Agenda Item #: 3
SUB-002602-2023

The Mobile Commerce Park Subdivision, Phase 1,
Resubdivision of Lots 2-A and 2-B

APPLICATION NUMBER 3 DATE September 7, 2023

SITE PLAN

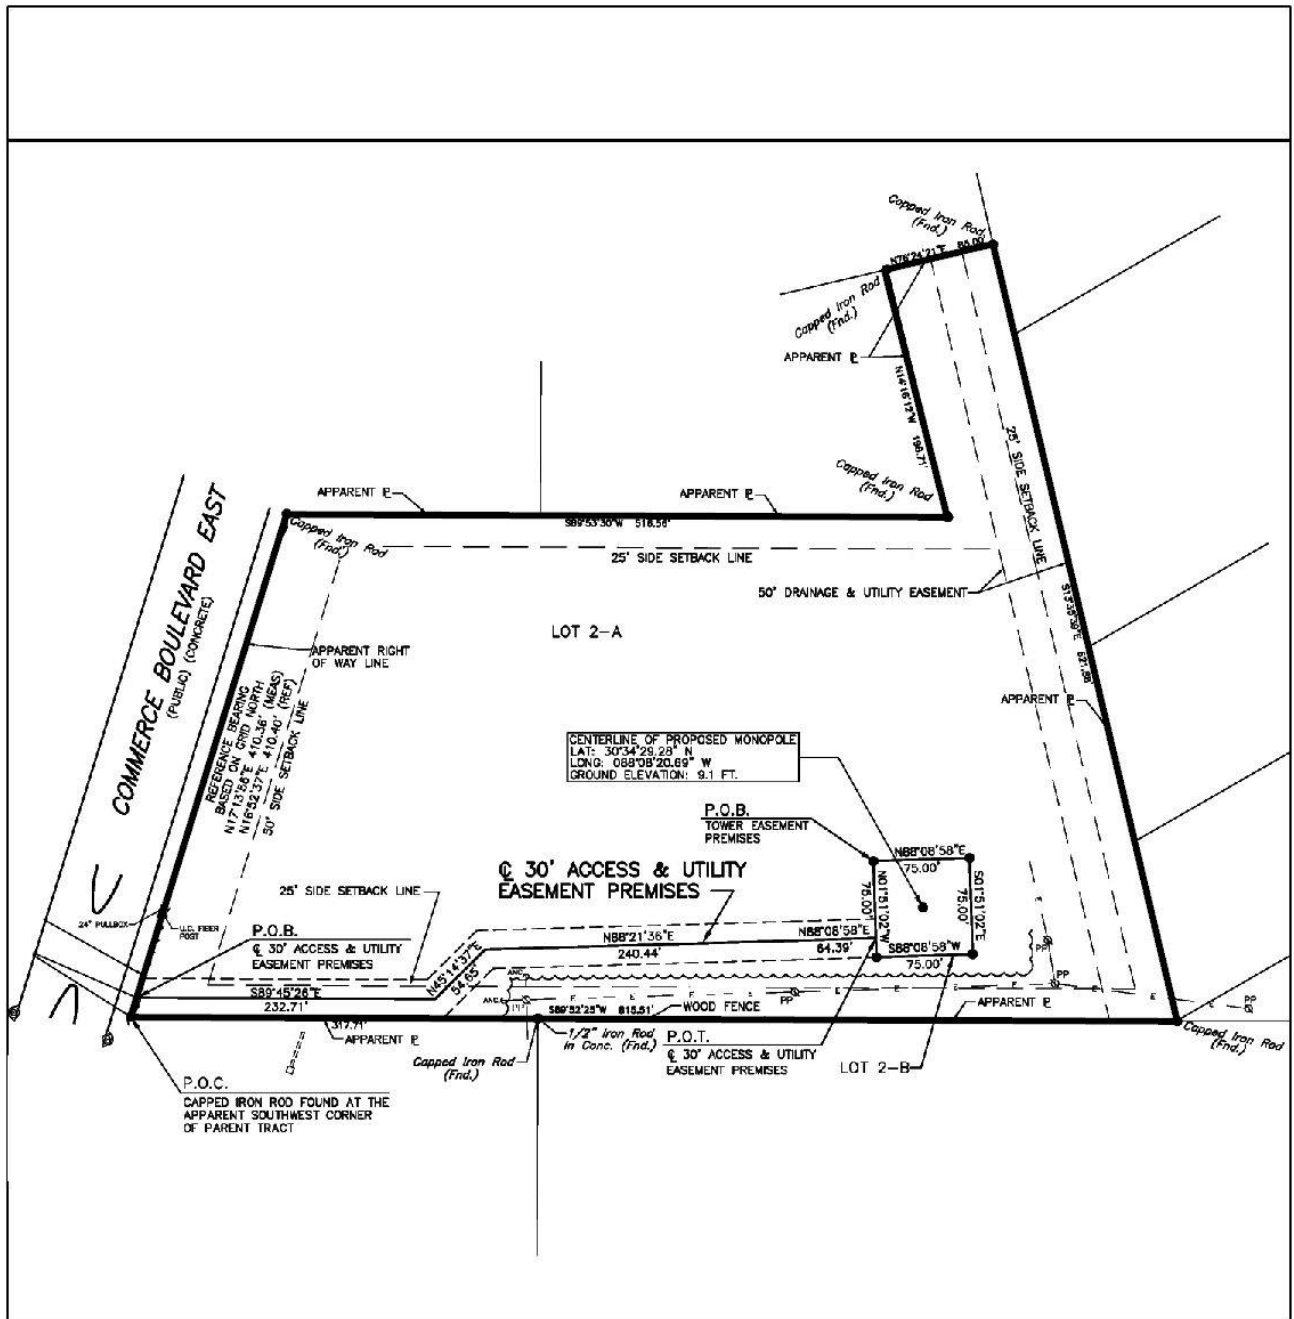
- A. Provide all of the required information on the SUBDIVISION PLAT (i.e. signature blocks, signatures, certification statements, written legal description, required notes, legend, scale, bearings and distances) that is required by the current Alabama State Board of Licensure for Professional Engineers and Land Surveyors.

- B. Provide and label the monument set or found at each subdivision corner.
- C. Add a Vicinity Map.
- D. Provide a written description for the subdivision boundary.

- E. Show and label the Commerce Blvd. E. ROW width and clarify the distance from the subdivision frontage to the centerline of the ROW.
- F. Show and label all flood zones. New maps went into effect on June 5, 2020.

- G. Show and label the MFFE (Minimum Finished Floor Elevation) on each lot that contains an A, AE, or X (shaded) flood zone designation. BFE = 11.
- H. Add a signature block for the Owner, Notary Public, Planning Commission, Traffic Engineer, and City Engineer.

Lot 2-A of the subject site has linear frontage along Commerce Boulevard East, a minor street with curb and gutter requiring a 50-foot right-of-way. The preliminary plat does not illustrate the existing right-of-way at this location, and as such, should be revised to either label a compliant right-of-way width or illustrate dedication sufficient to provide 25 feet from the centerline of Commerce Boulevard East.

Lot 2-B of the subject site, as proposed, does not have direct frontage onto public right-of-way. The preliminary plat does, however, illustrate a 30-foot access and utility easement which grants access to the proposed lot from Commerce Boulevard East. It should be noted that Section 64-3-2.A.1. of the Unified Development Code (UDC) allows access to be provided by a recorded dedicated easement, but a waiver of Section 6.C.4. of the Subdivision Regulations will be required if approved.

A 50-foot side yard setback is illustrated along Commerce Boulevard East and a 25-foot side setback is illustrated along all sides and the rear of the property. However, only a 25-foot front yard setback and 0- or 5-foot side and rear yard setbacks are required for lots in a B-5, Office Distribution District, per Article 2 Section 64-2-16 of the UDC. Additionally, per Section 6.C.8. of the Subdivision Regulations only a front yard setback is required to be illustrated on a Final Plat. The applicant may retain the setbacks as illustrated, but if approved and the plat recorded in the Mobile County Probate Court depicts the setbacks as illustrated, future development of the properties will be subject to setbacks greater than what are required by the UDC. As such, at least a 25-foot front yard setback should be illustrated along Commerce Boulevard East, and no side or rear setbacks should be illustrated on the Final Plat, if approved.

The preliminary plat should be revised to depict the lot size labels in both square feet and acres on the Final Plat, or a table should be furnished on the Final Plat providing the same information.

Lot 2-A contains access, drainage and utility easements; therefore, a note should be required on the Final Plat stating that no structure may be constructed or placed within any easement without the permission of the easement holder, if approved.

1. Revision of the plat to label all abutting streets with their right-of-way widths or illustrate dedication sufficient to provide 25 feet from the centerline of Commerce Boulevard East;

2. Retention of at least a 25-foot front yard setback along Commerce Boulevard East;
3. Removal of side or rear setbacks from the Final Plat;
4. Revision of the plat to include lot size labels in both square feet and acres on the Final Plat, or the furnishing of a table on the Final Plat providing the same information;

5. Placement of a note on the Final Plat stating that no structure may be constructed or placed within any easement without the permission of the easement holder;
